Response to Submissions

Cooloo Wind Farm (ACP
Ref. 323761)

Document Title: **Response to Submissions**

Project No. 190723	Drawing No. Figure 6-4
------------------------------	----------------------------------

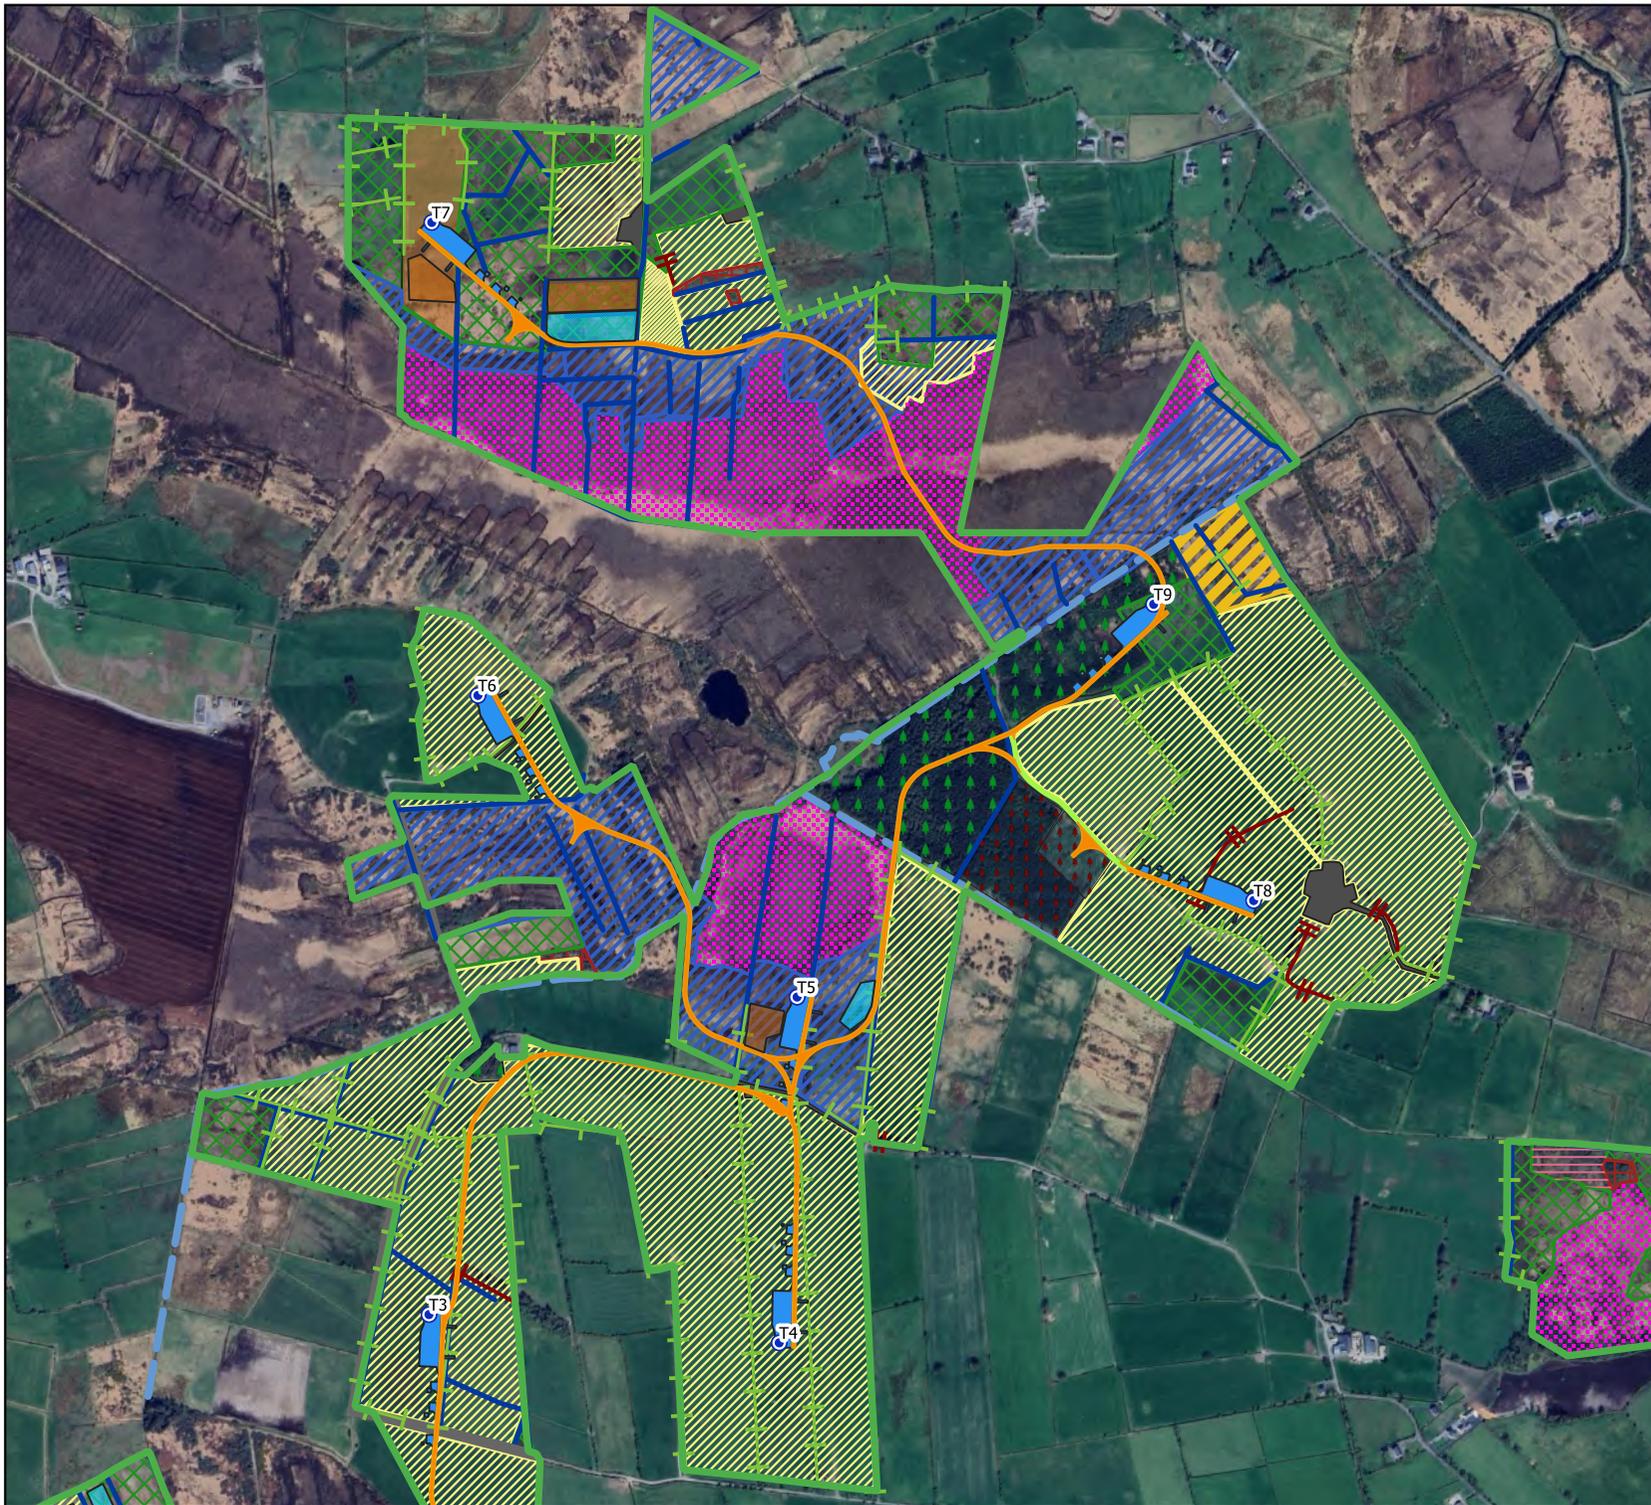
The potential for impacts on woodland habitats and linear features (treelines/hedgerows) has been considered within Chapter 6 of the EIAR. Section 6.4.1.2 describes the existing woodland habitats. Section 6.4.1.5.2 and Section 6.4.1.5.3 details the existing hedgerow and treeline habitats within the site. Figure 6-4, Figure 6-5 and Figure 6-6 of Chapter 6 of the submitted EIAR are shown below and shows the habitats and contextualises their diversity on the Site. It is noted that these figures are not included in the digital copy of Chapter 6 but is included in in the hard copy of the EIAR, which is publicly available at the offices of both the Commission and GCC. The figure is a visual representation of the information included in Chapter 6, Section 6.4.1, of the submitted EIAR and does not present any new or additional information.

Project No. 190723	Drawing No. Figure 6-7
------------------------------	----------------------------------

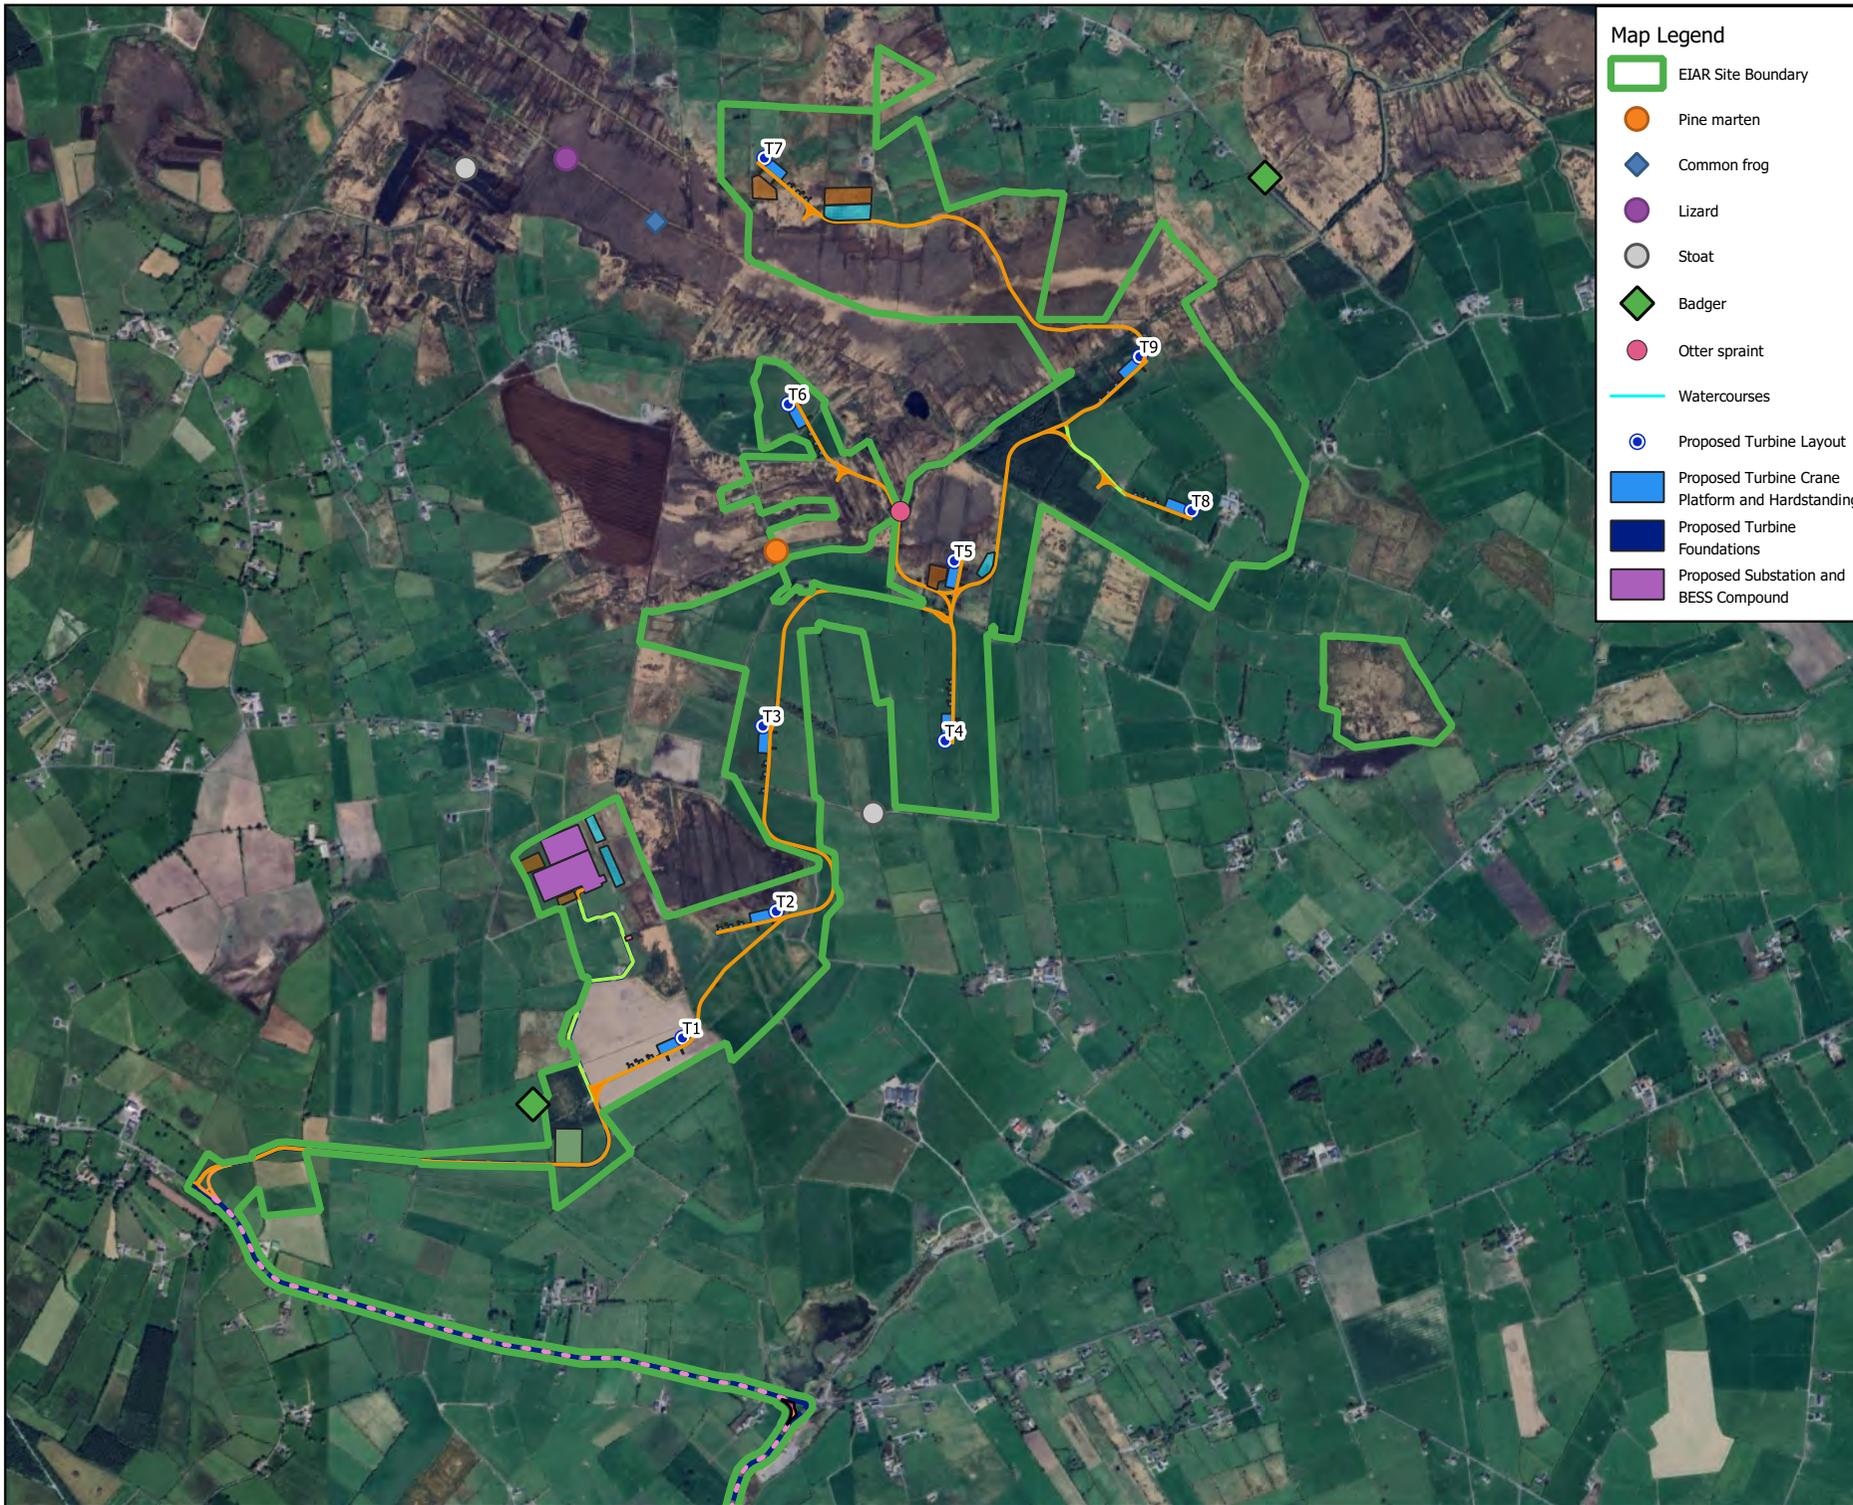
As detailed in Section 6.2.3.3.1 of the EIAR, badger surveys were undertaken during all of the multidisciplinary walkover surveys undertaken between 2021-2025.

Figure 6-7 of Chapter 6 of the submitted EIAR is shown below and shows the areas within which evidence of fauna was observed across the Site. It is noted that this figure is not included in the digital copy of Chapter 6 but is included in the hard copy of the EIAR, which is publicly available at the offices of both the Commission and GCC. The figure is a visual representation of the information included in Chapter 6, Section 6.4.3, of the submitted EIAR and does not present any new or additional information.

Drawing Title	
European Designated Sites	
<small>Project Title</small>	
Cooloo Wind Farm, Co. Galway	
<small>Drawn By</small>	<small>Checked By</small>
EF	RW
<small>Project No.</small>	<small>Drawing No.</small>
190723	Figure 6-1
<small>Scale</small>	<small>Date</small>
1:200,000	18/09/2025

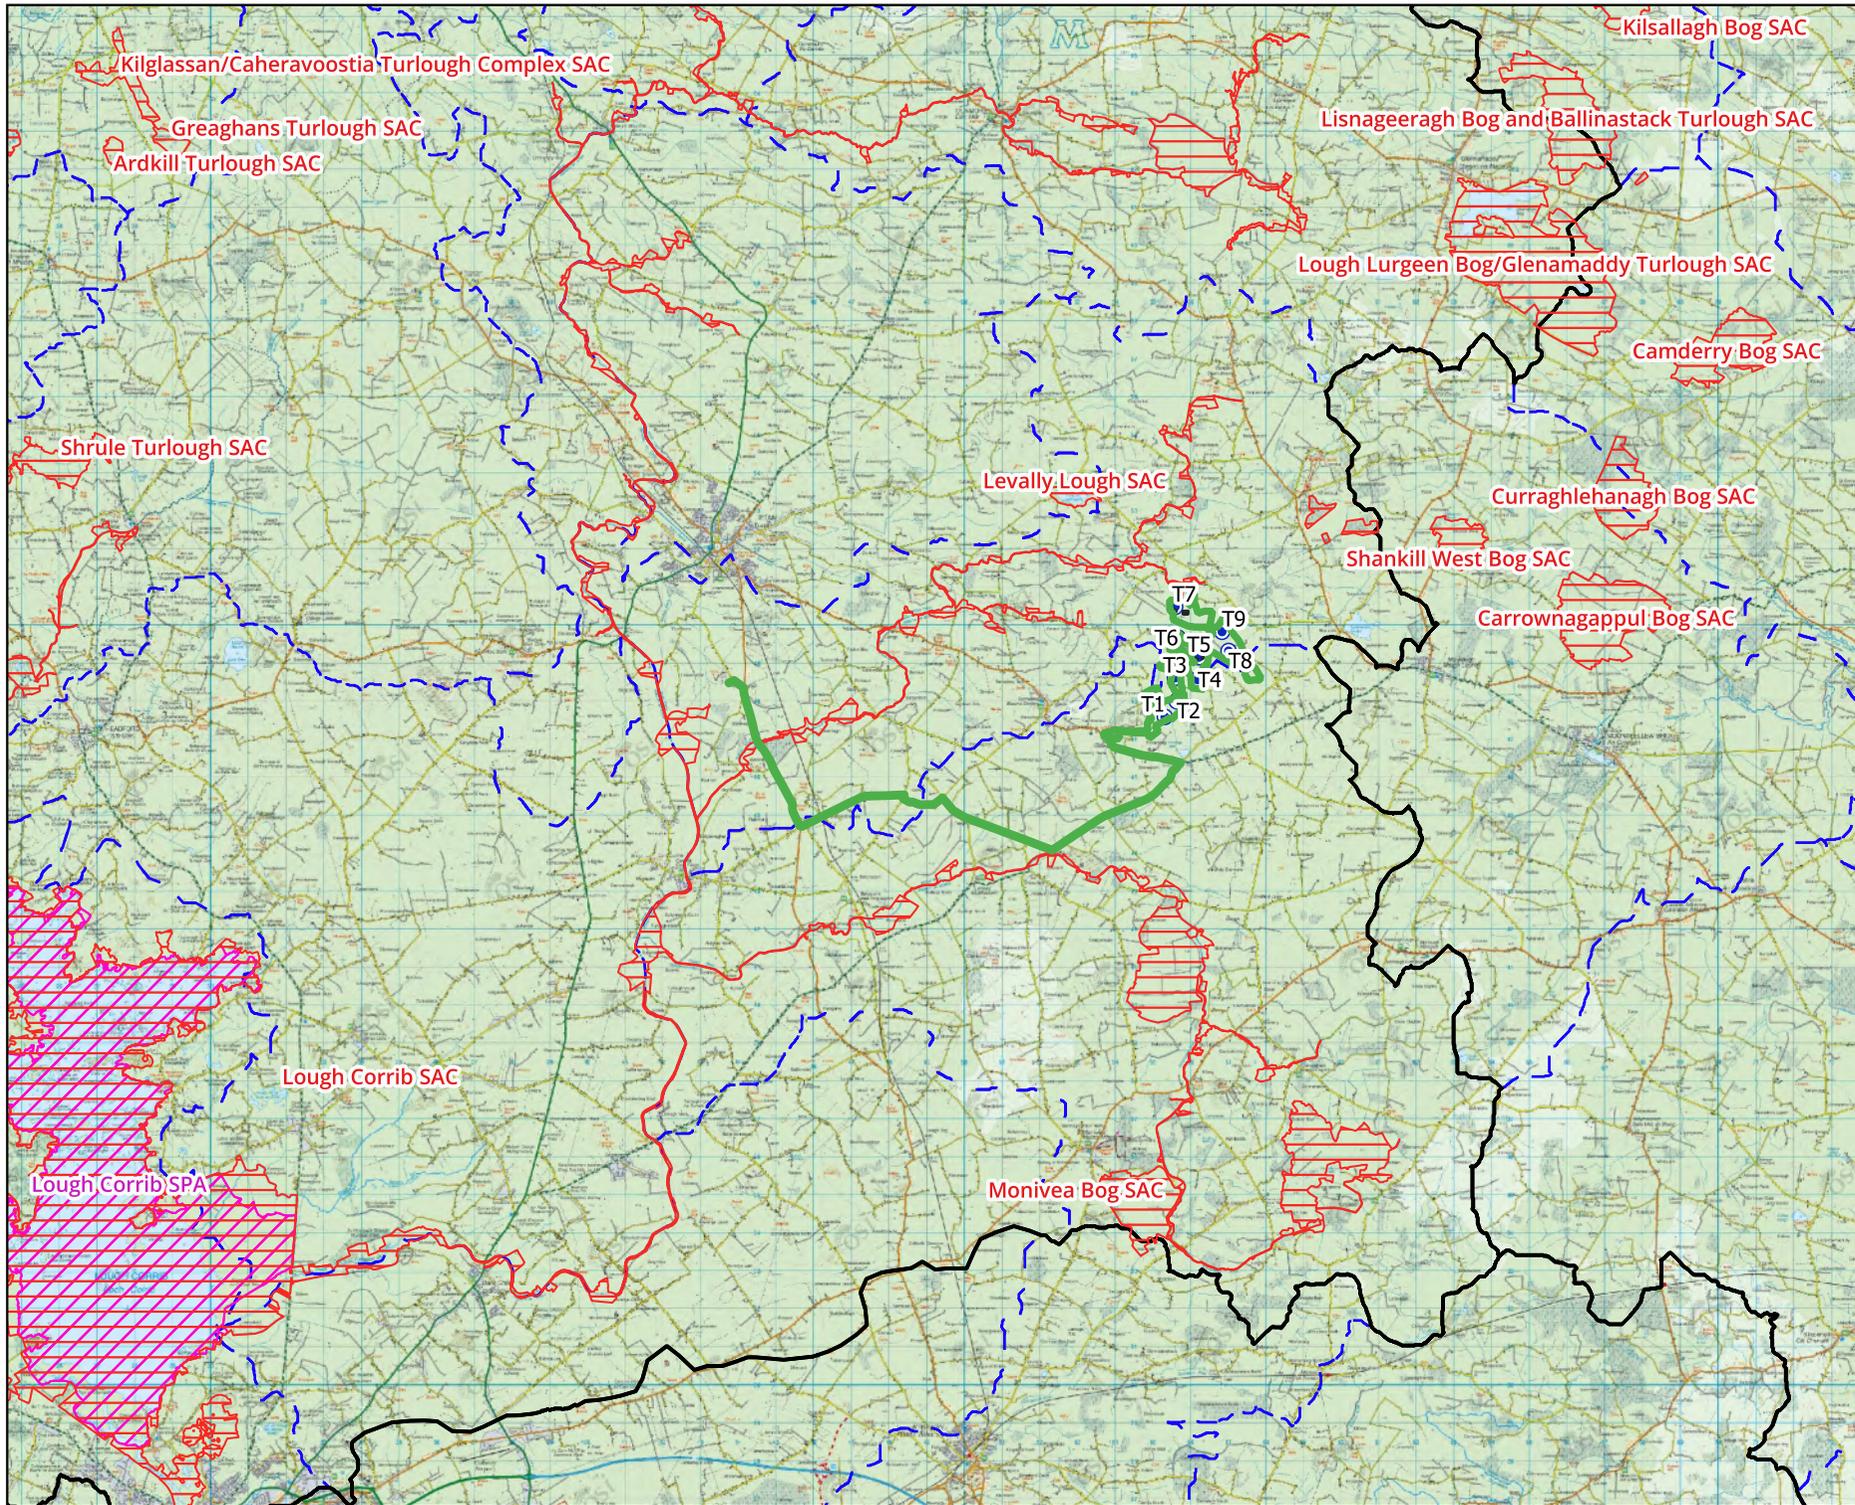
The Natura Impact Statement (NIS) produced for the Proposed Wind Farm has addressed the potential for indirect effects on the Lough Corrib SAC and Lough Corrib SPA. None of the Proposed Wind Farm is located within the SAC boundaries, however the proposed grid connection crosses the SAC at the Grange River (Ballinderry Bridge), an existing watercourse crossing in one location, as detailed in Figure 4-1 of the NIS. Mitigation has been provided for construction phase hydrological impacts in Section 6.2.3, which provides a suite of mitigation to prevent any adverse effects on the SAC and SPA, located downstream of the Proposed Wind Farm. Mitigation has also been provided for the potential effects from the removal of vegetation cover and progressive replacement of natural surface with low permeability surfaces during the operation phase, in Section 6.2.3.1.1 of the NIS.

Figure 6-1 and Figure 6-2 of Chapter 6 of the submitted EIAR is shown below and shows the European designated and nationally designated sites in proximity to the Site. It is noted that these figures are not included in the digital copy of Chapter 6 but are included in in the hard copy of the EIAR, which is publicly available at the offices of both the Commission and GCC. The figures are a visual representation of the information included in Chapter 6, Section 6.3.1.2, of the submitted EIAR and does not present any new or additional information.
